# TECHNICAL SERVICE BULLETIN

NO. 75-F-5

# Triumph

WHEEL CYLINDER SEALS

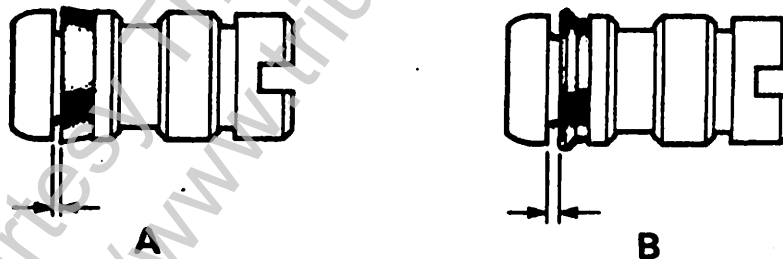
The straight taper wheel cylinder seals, shown at 'A', are being superseded by chamfered lip seals, 'B'. These are shorter than those of the straight taper pattern. (Refer to diagram below).

This difference in length means that the seal occupies less of the groove in the piston.

The increased clearance that results is intentional and must not be taken to indicate an incorrect seal.
